# Document G701® – 2017

## Change Order

**PROJECT:** *(Name and address)*  
HCHS CTE Renovation  
2424 Zion Road  
Henderson, KY 42420

**CHANGE ORDER INFORMATION:**  
Change Order Number: 01  
Date: October 15, 2024

HENDERSON COUNTY SCHOOLS  
HENDERSON COUNTY HIGH SCHOOL  
CITE RENOVATION  
**BUILDING ELEVATIONS - CLASSROOM ADDITION**

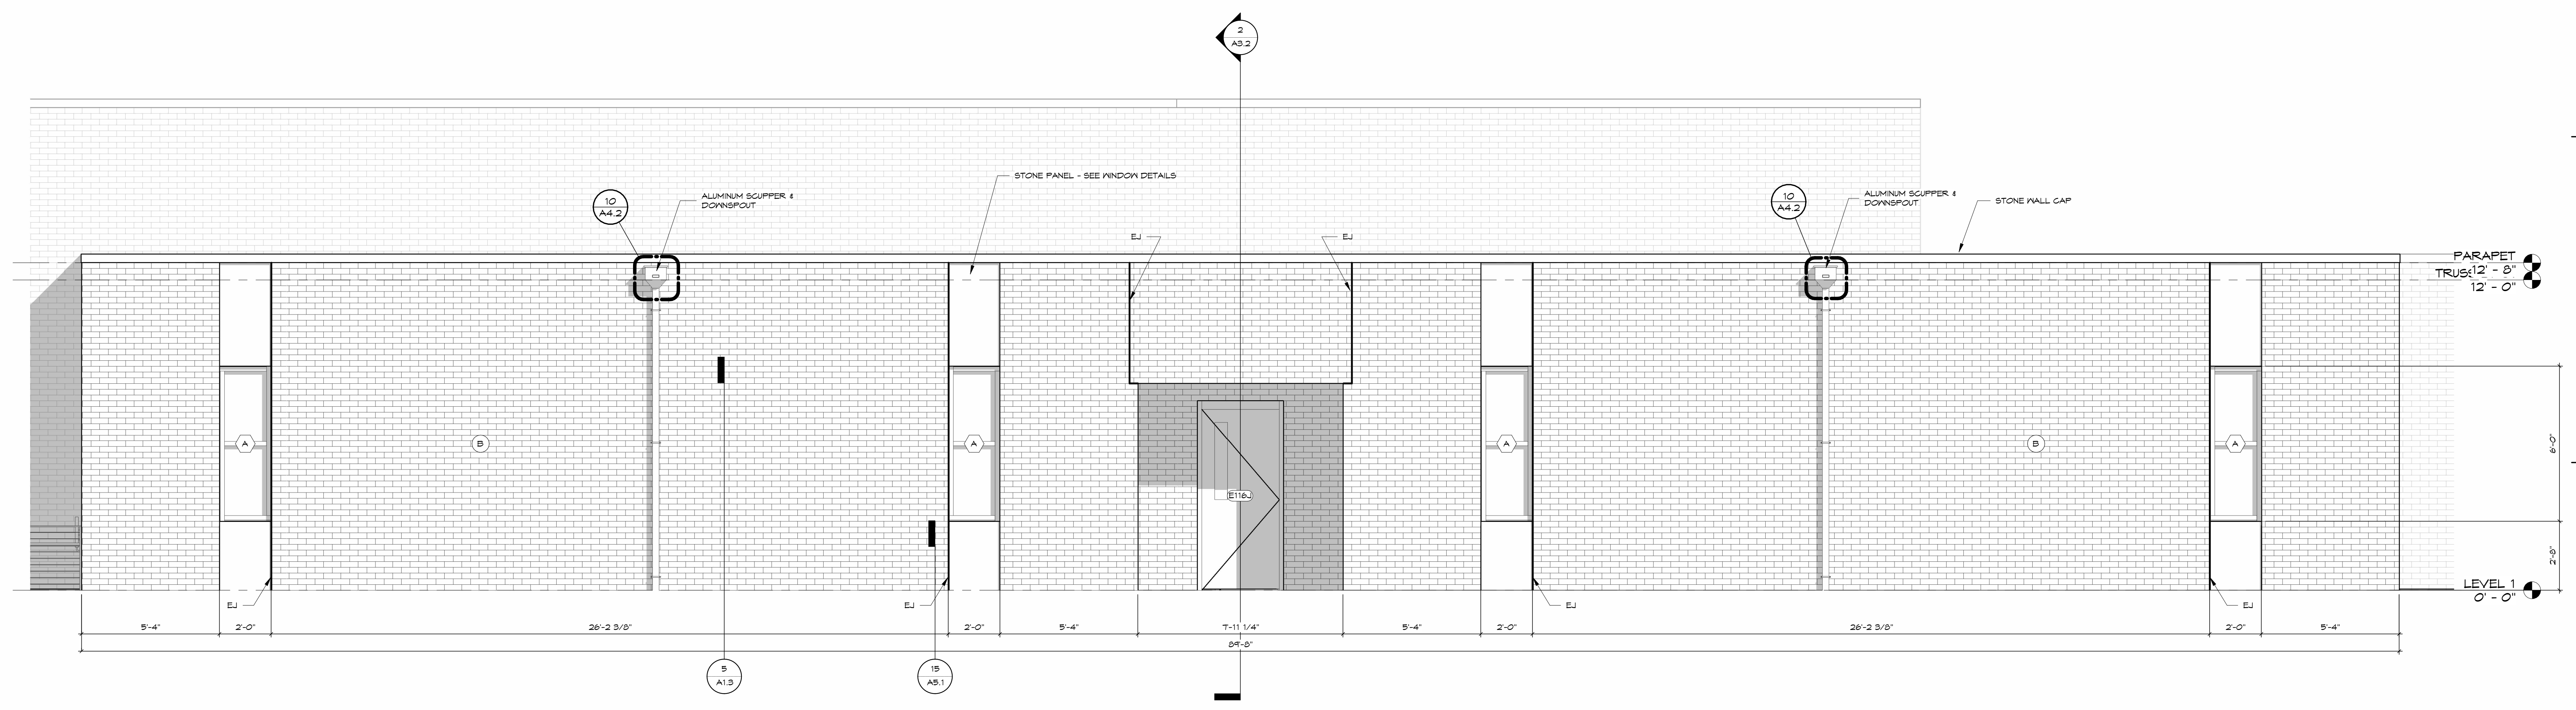
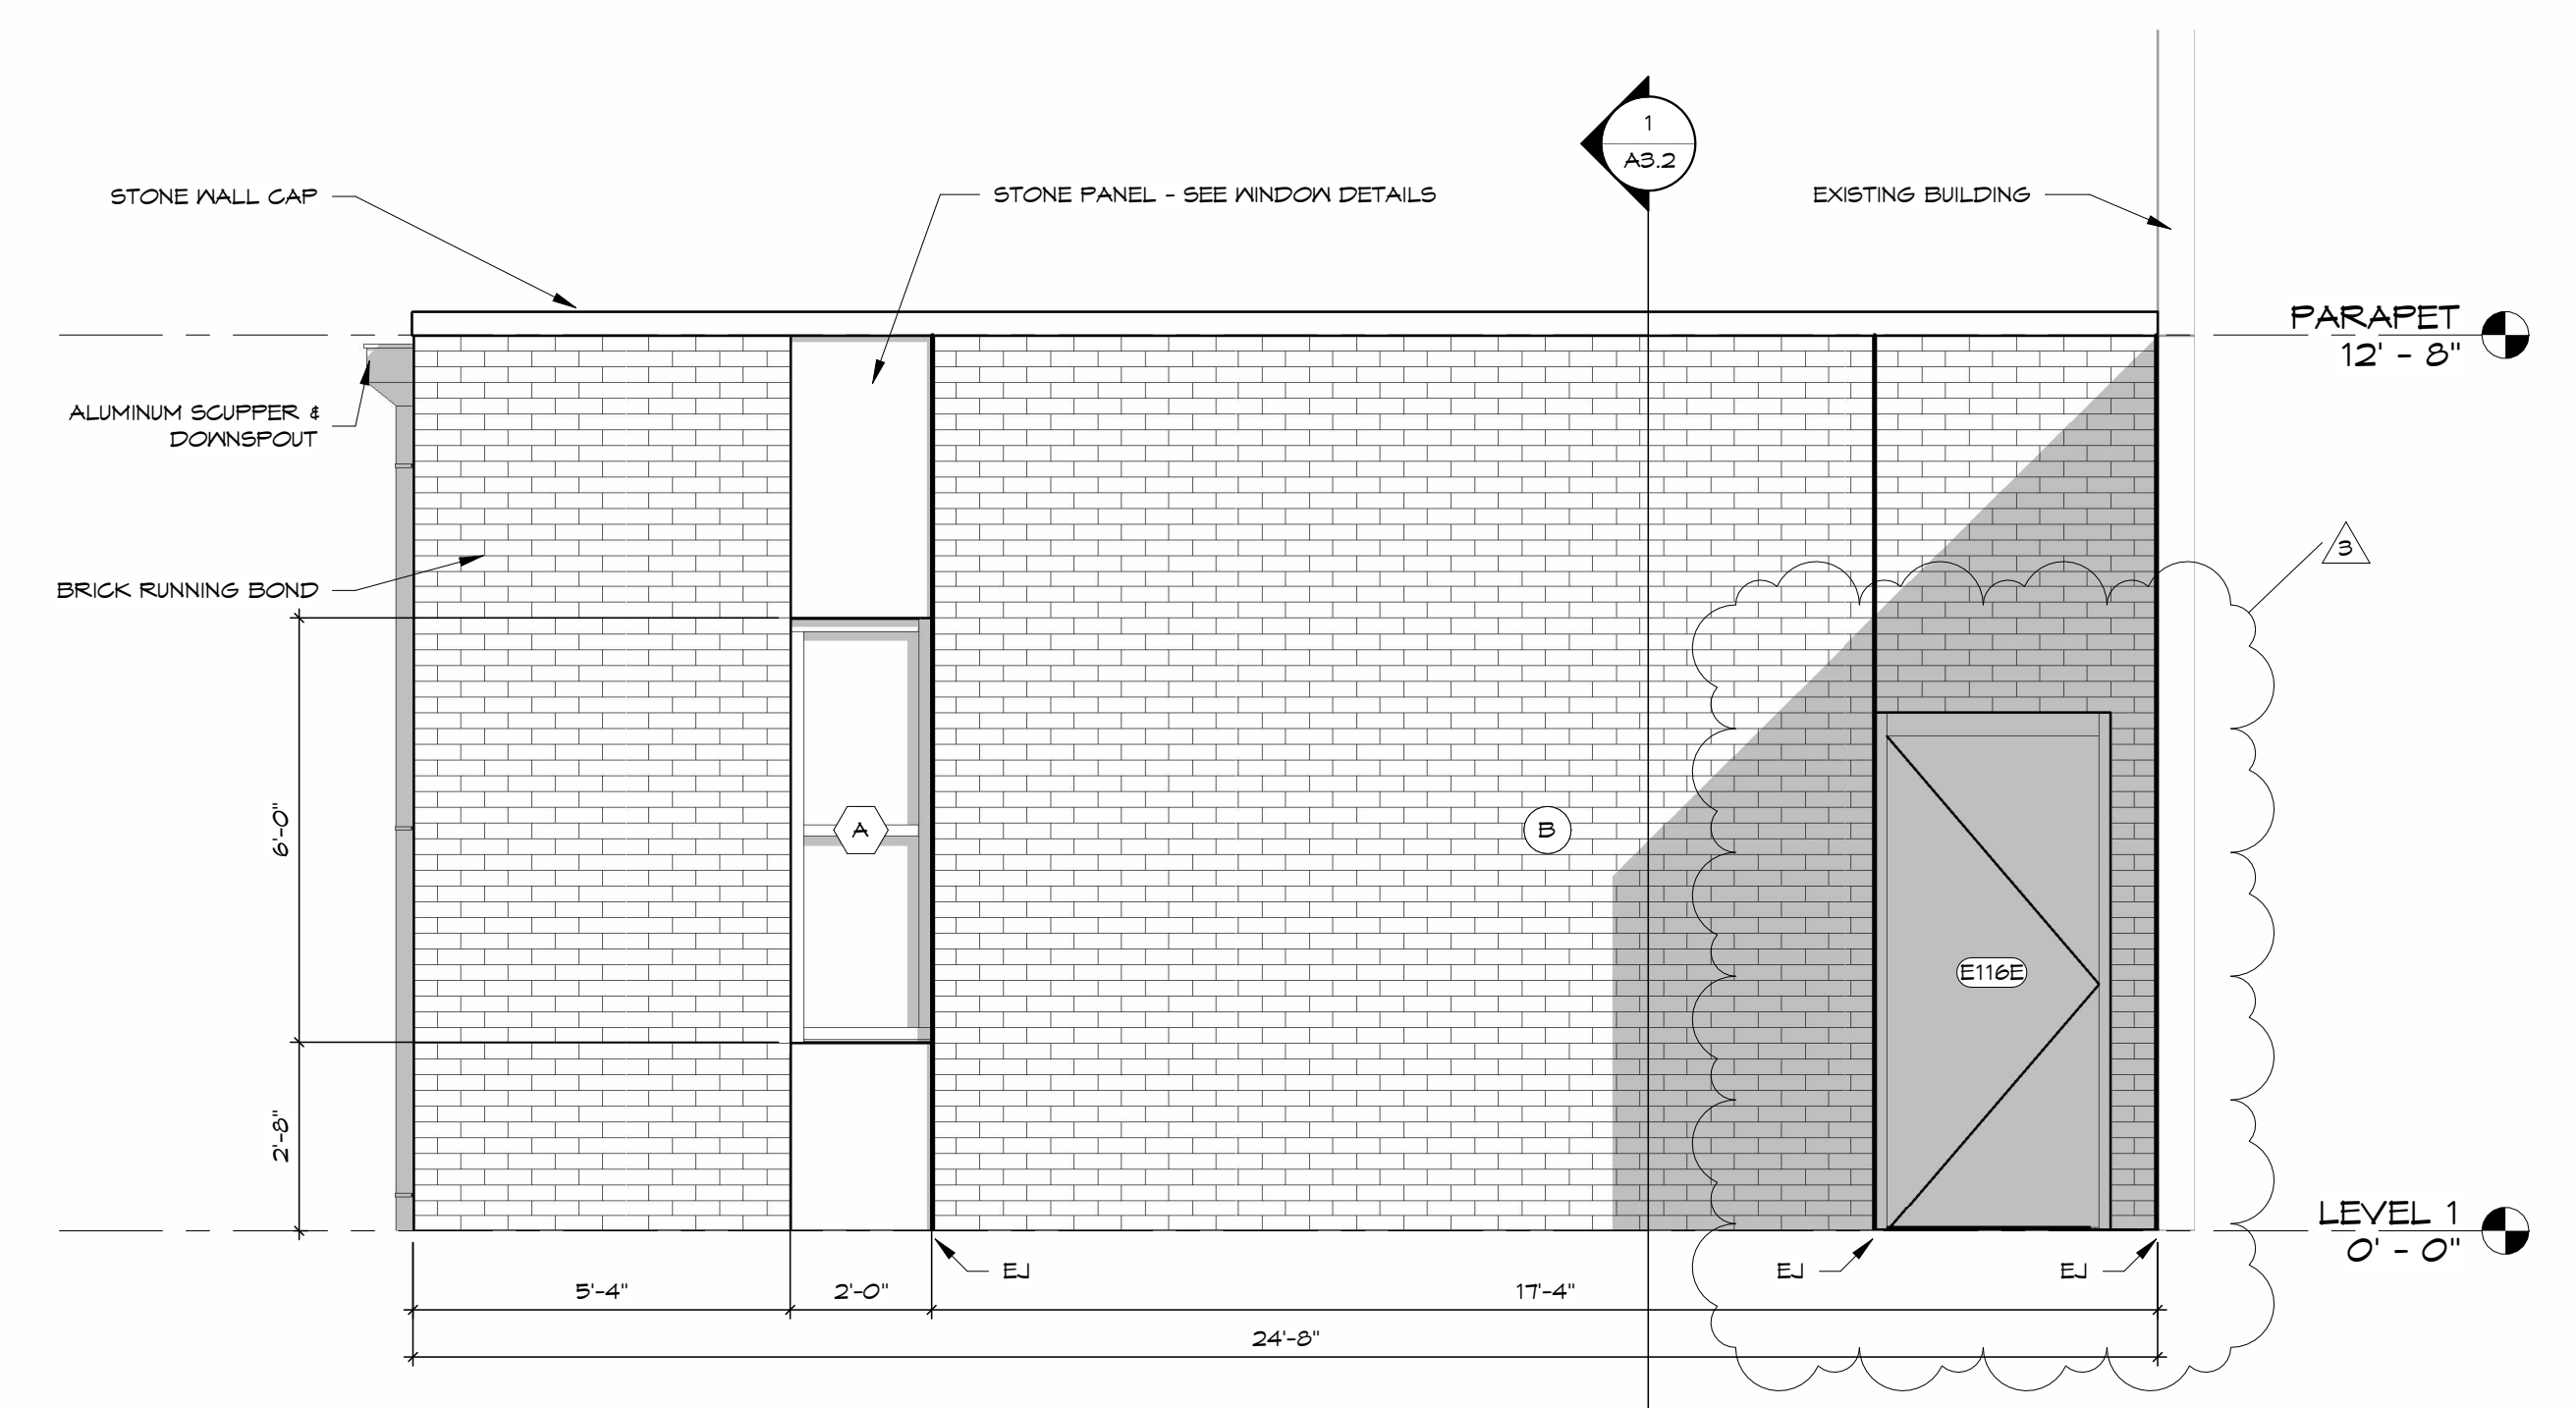
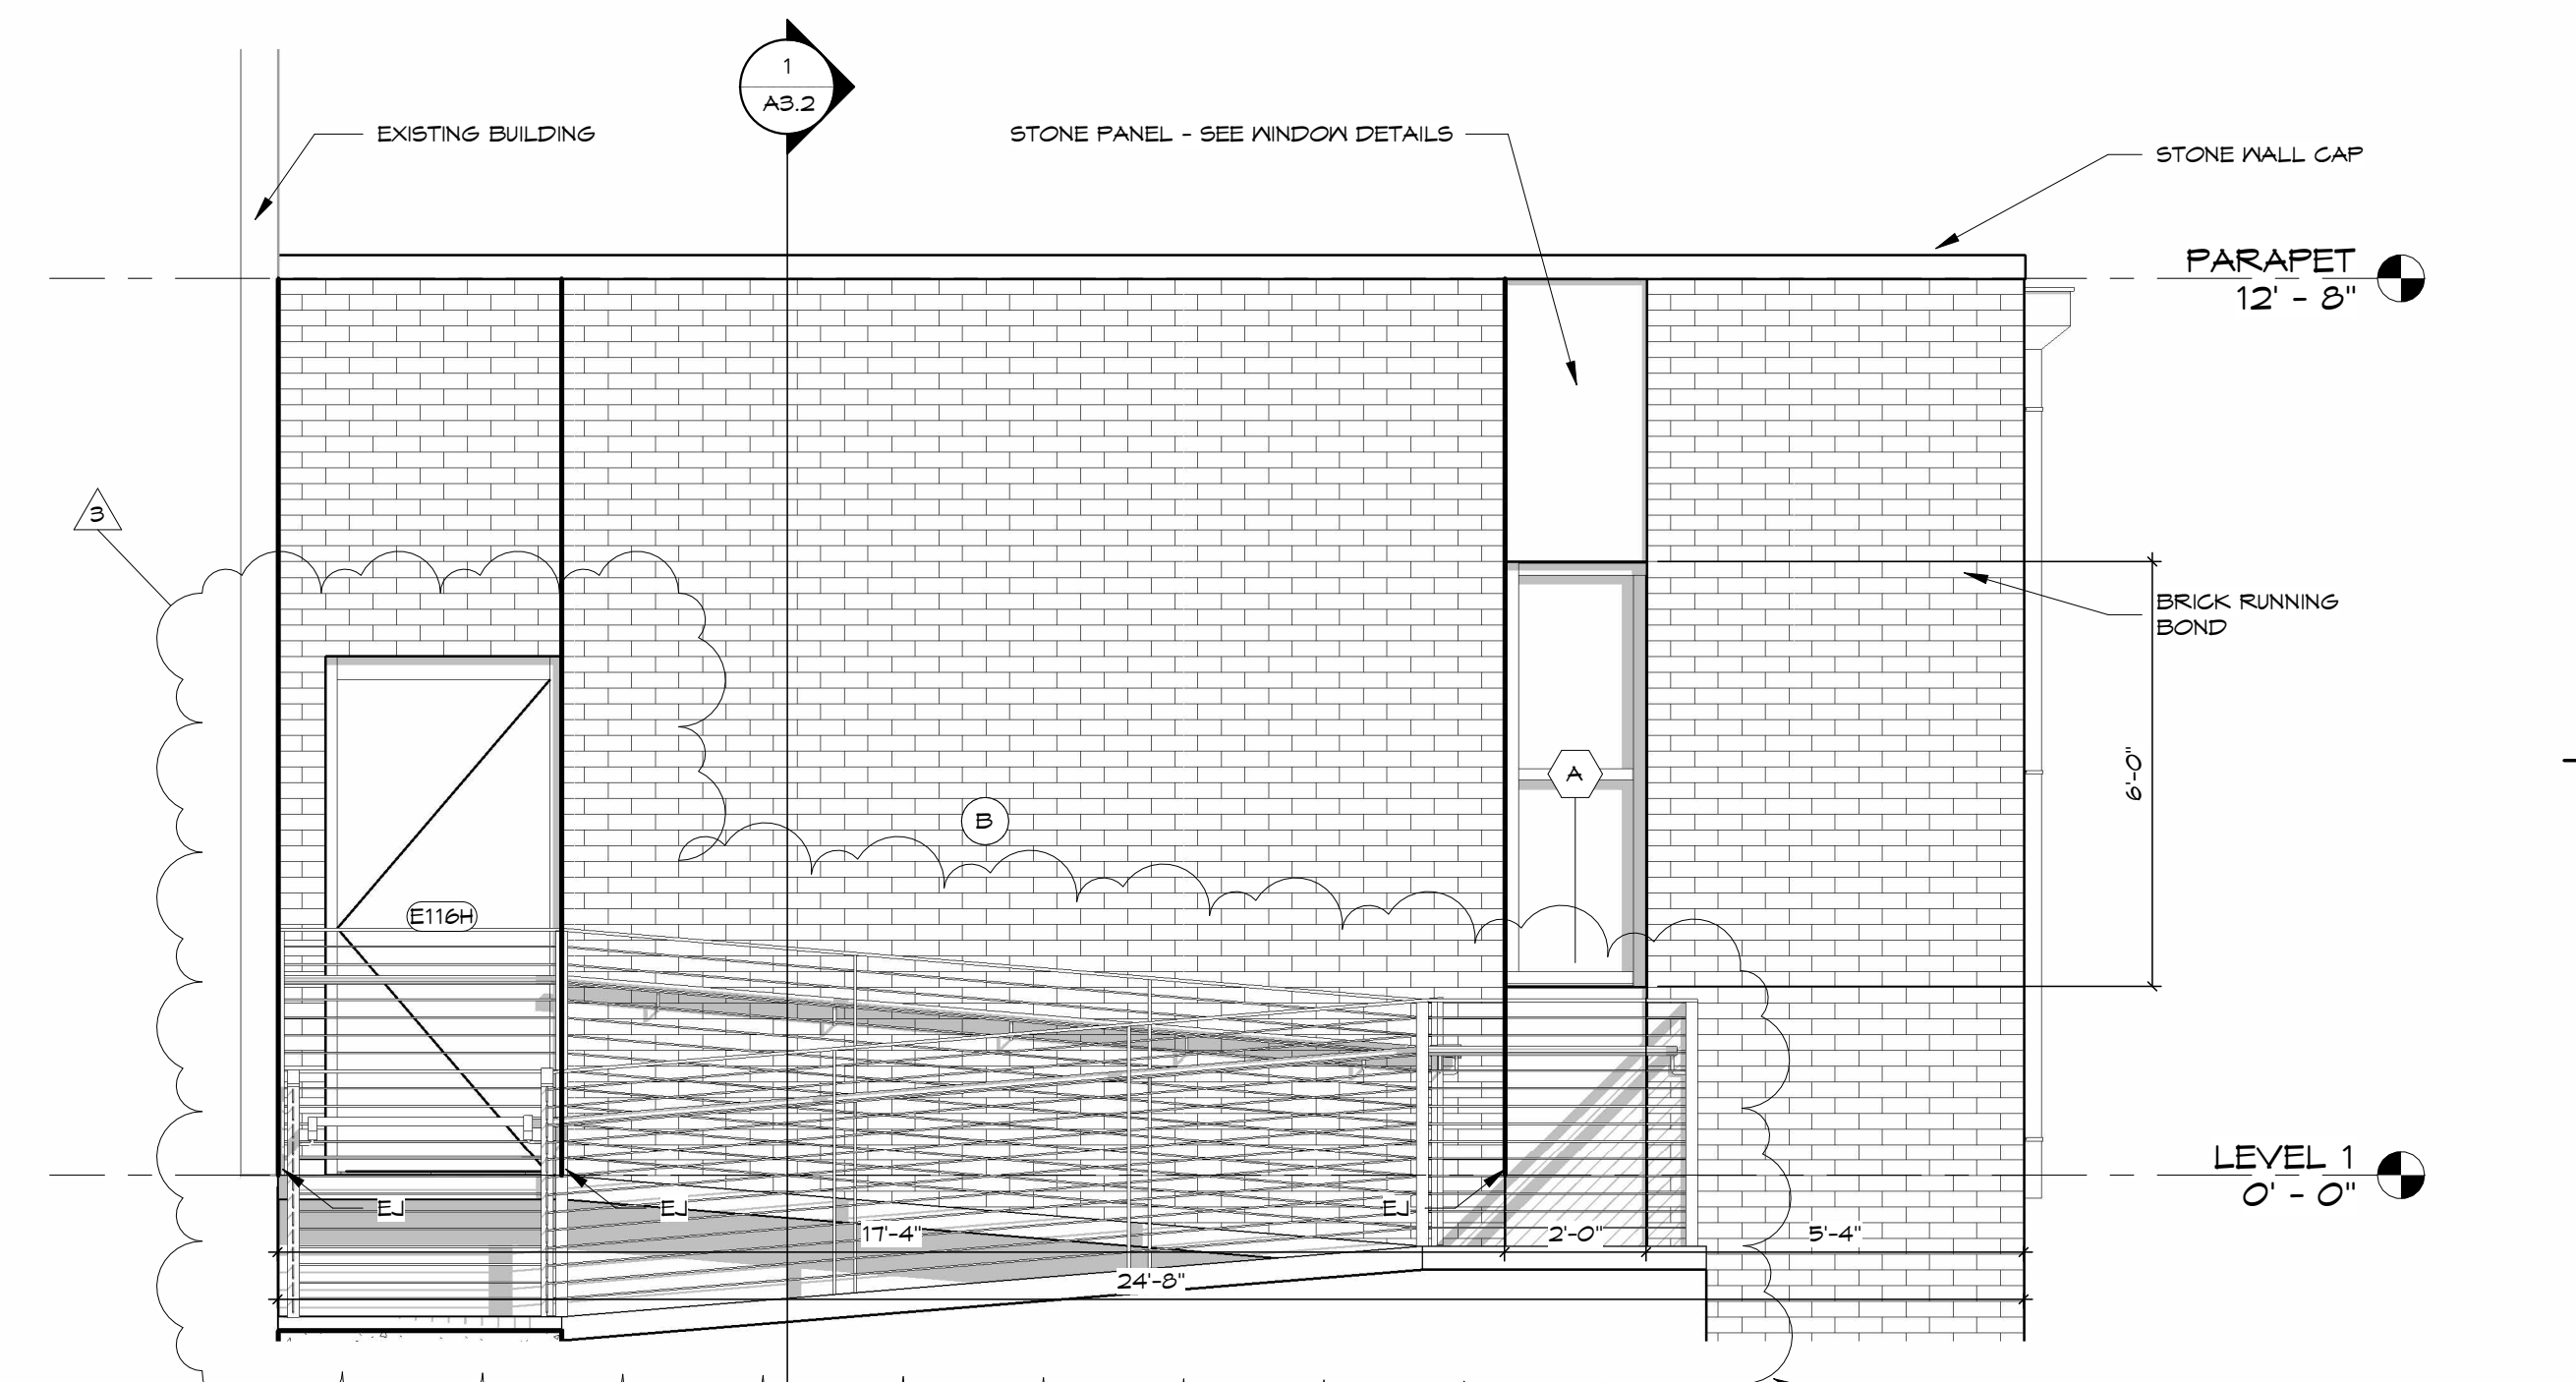
Provide a cost for the HBC required 2 means of exit for each of the new classroom additions.  
Includes:

- New Exit walk and landing pad
- New Exit Ramp & Guard Rails
- New Exterior Sconce Lighting at each classroom exterior door
- New Interior Exit signage at each classroom exterior door
- New Fire Alarm Pull at each classroom exterior door (interior)
- Revision of classroom exterior door panel type
- Revision of LVT to MCT (Mark C on Room Finish Legend)
